# **Service Bulletin**

**KNOCKING / SQUEAKING NOISE FROM FRONT STRUT BEARING**

**Bulletin No:** 02-003/15

- This bulletin supersedes the previous bulletin 02-005/13, issued on 08/24/13 and 11/11/13. The APPLICA-BLE MODEL(S)/VINS, DESCRIPTION, REPAIR PROCEDURE, PART(S) and WARRANTY INFORMATION have been revised.
- Changes are noted below in Red beside the change bar.

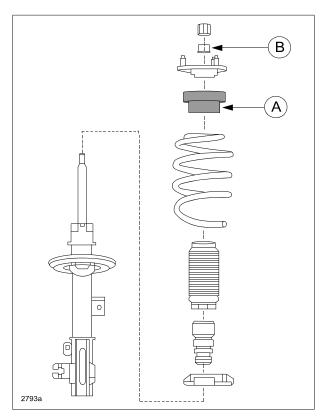
Some vehicles may exhibit a knocking / squeaking noise from the front strut bearing (A) when driving on rough roads and/or when turning the steering wheel while the vehicle is stopped.

The noise may be due to upper front strut bearing damage or it may be due to stick/slip between the front strut bearing and coil spring.

To eliminate the noise, the following mass-production changes have been made:

- 1. The material and production method of the front strut bearing has been changed.
- 2. A protector has been installed onto the coil spring.

**NOTE:** The piston rod nut (B) requires replacement when the front strut bearing is replaced.

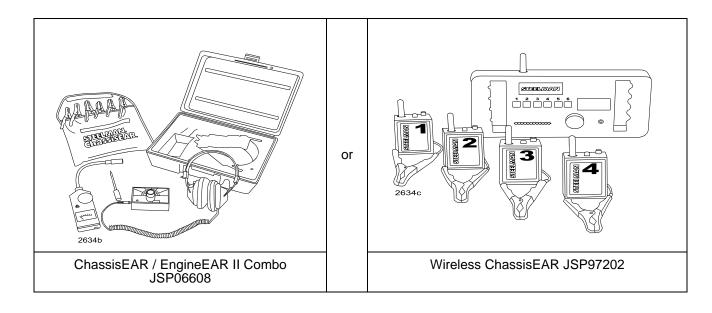
- 1. Verify the customer concern of knocking or squeaking noise coming from the front suspension.
- 2. Is the noise coming from the upper part of front shock absorber when turning the steering wheel?
  - Yes Proceed to Step 3.
  - No This bulletin does not apply.
- 3. Is the strut bearing broken as shown below?
  - Yes Proceed to Step 4.
  - No Proceed to Step 5.

- 4. Replace the front strut bearing with a new one according to MS3 online instructions or the Workshop Manual (section 02-13 FRONT SHOCK ABSORBER AND COIL SPRING DISASSEMBLY/ASSEMBLY).
- 5. Use Special Service Tool (SST) ChassisEAR / EngineEAR II Combo JSP06608 or Wireless ChassisEAR JSP97202 to confirm noise is coming from the upper part of front shock absorber:
- NOTE: SST JSP06608 and JSP97202 are available for purchase on Mazda E-Store.

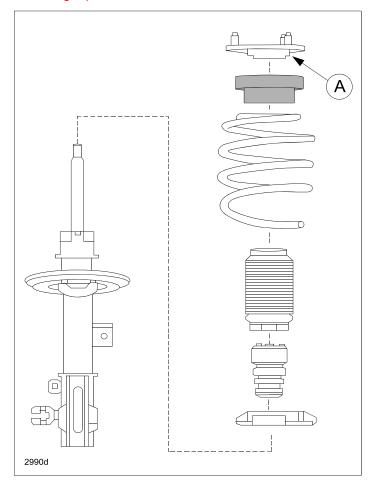
- Before removing the mounting rubber (A), mark its original position so it can be re-installed later to the same position.
- It is not necessary to adjust the front wheel alignment because the front shock absorber and mounting rubber are not being replaced.

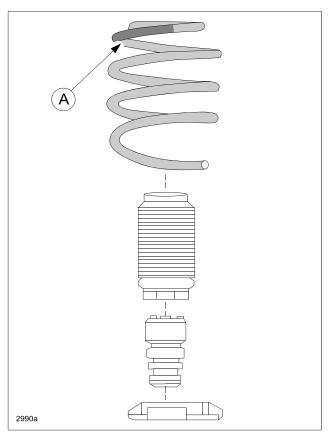
1. Remove the front strut bearing and coil spring according to the MS3 online instructions or the Workshop Manual (section 02-13 FRONT SHOCK ABSORBER AND COIL SPRING DISASSEMBLY/ASSEMBLY).

NOTE: \*If the front strut bearing is found to be damaged, replace it with a modified part.

- 2. Install a protector on the front coil spring according to "Coil Spring Protector (A) Installation" below.
- 3. Reinstall the front strut bearing and coil spring according to MS3 online instructions or the Workshop Manual (section 02-13 FRONT SHOCK ABSORBER AND COIL SPRING DISASSEMBLY/ASSEMBLY).
- 4. Repeat Steps 1 3 on the opposite side front suspension.
- 5. Verify repair.

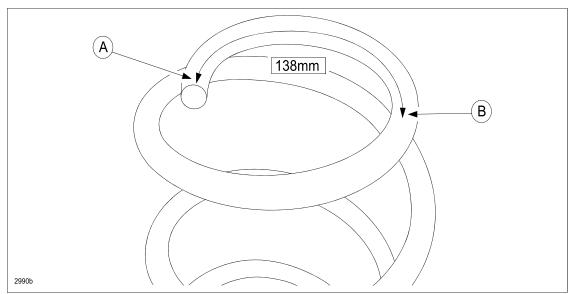
- a. Starting from the top of the coil spring, degrease the spring 1.5 coils downward.
- b. Cut a thin strip of paper to 138 mm in length (or use a cloth type measuring tape).

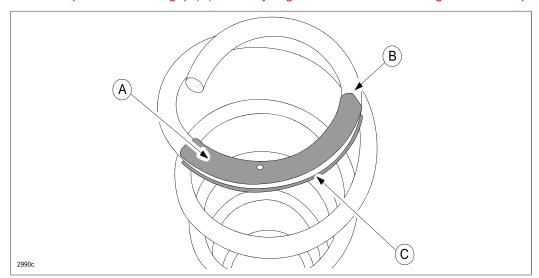
c. Place the strip of paper (or cloth measuring tape) along the inner side of the coil spring starting at point (A).

e. Install the protector (A) onto the coil spring aligning the end (slant cut side) with the marking at spot (B). **NOTE:** Install the protector so the gap (C) is evenly aligned around the outer edge of the coil spring.

f. The inner side of the protector contains adhesive glue. After installing the protector onto the spring, press the inner side to firmly adhere it to the spring.
